DATE: September 17, 2020
TO: Prospective Respondents
FROM: Amy Lucey, Contracts Administrator
SUBJECT: Addendum #3 to Invitation for Bids # 35868, Crane Creek M-1 Canal Restoration

As a result of inquiries, the following clarifications/changes are provided for your information. Please make all appropriate changes to your bid documents. Note: changes are reflected with original language shown with strike-through and new language is underlined.

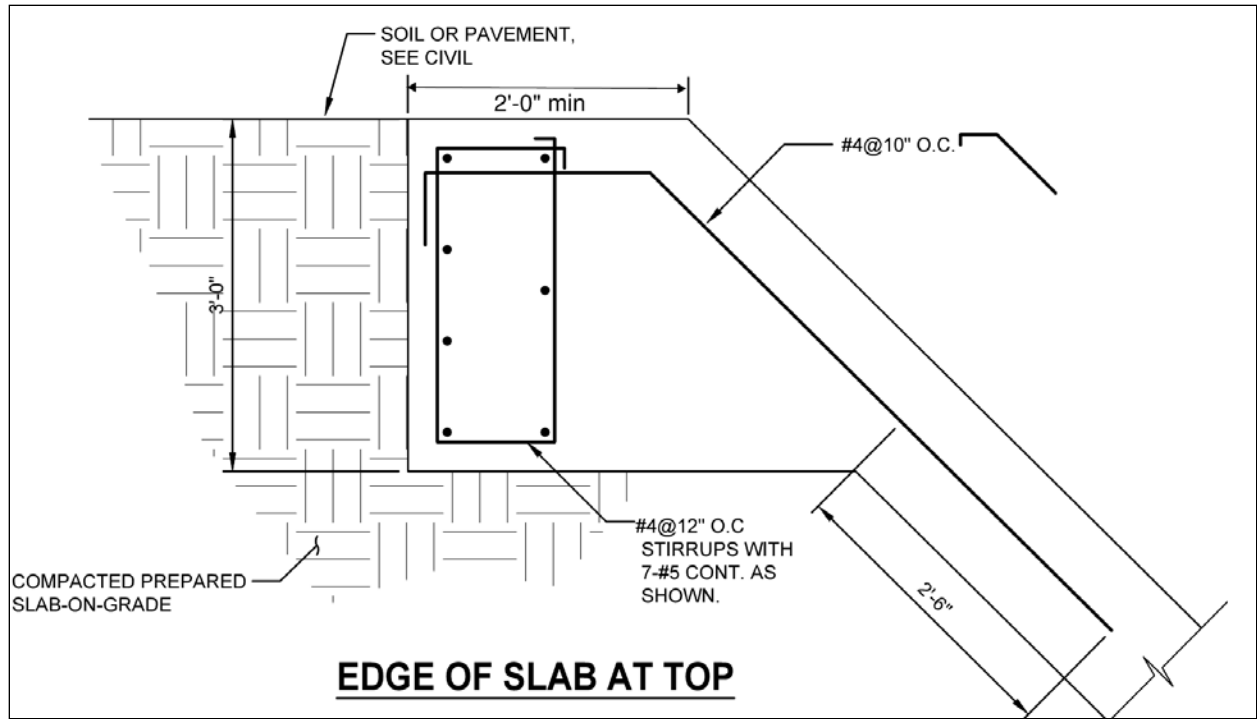
- Q10. Permanent bollards details are shown on sheets C5-3 and C5-8. Section A-A on Sheet C5-3 indicates the bollards are to be installed at 5' o.c. along the top slope of the weir behind the fencing. The detail on C5-8 directs us to install "as shown on the drawings or as directed in the field". There are no specific bollards shown along the top of the weir beyond the note to install at 5' o.c. Please clarify what, if any, bollards are required.

- A10. Please delete the requirement for bollards from Section A-A. Add FDOT safety railing at the locations shown on the sketch below.**

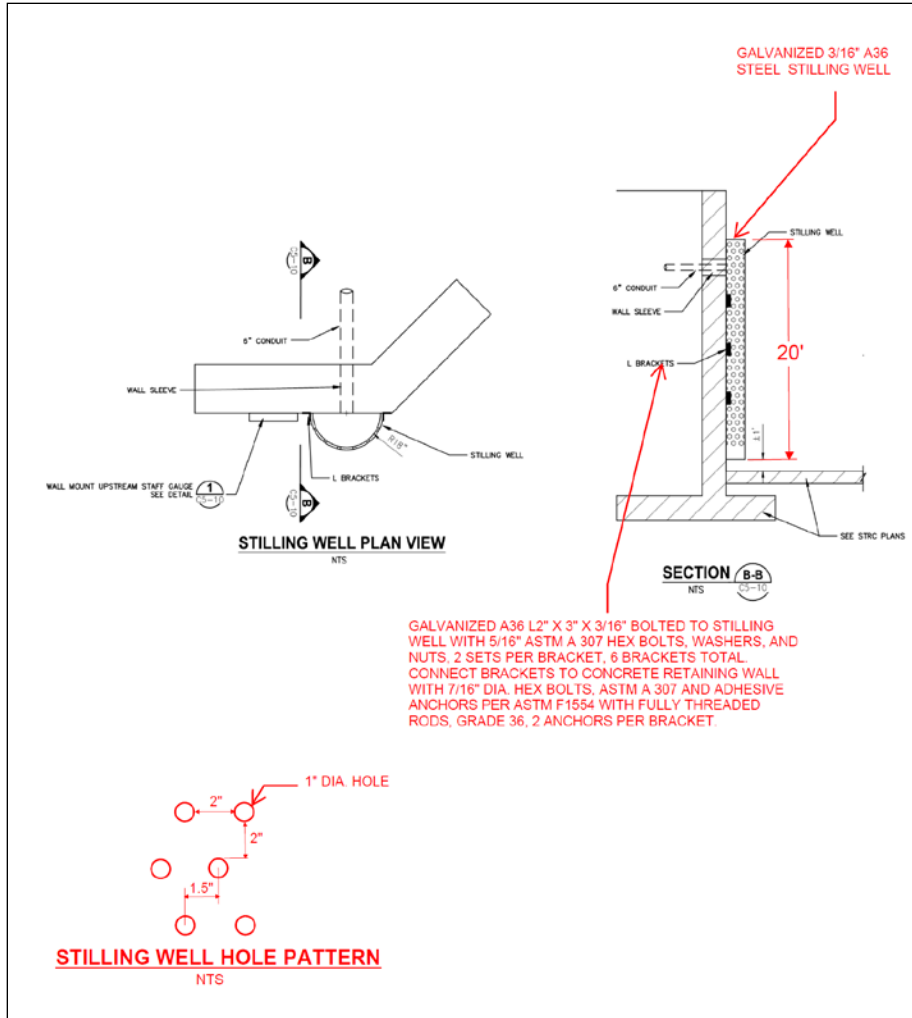
- Q32: Detail A/S5-3 for the edge of slab at top has no dimensions for the concrete. How deep is it at the top? How far does the bottom extend until it intersects with the bottom of the sloped slab?

A32: Below is a revised Edge of Slab detail.
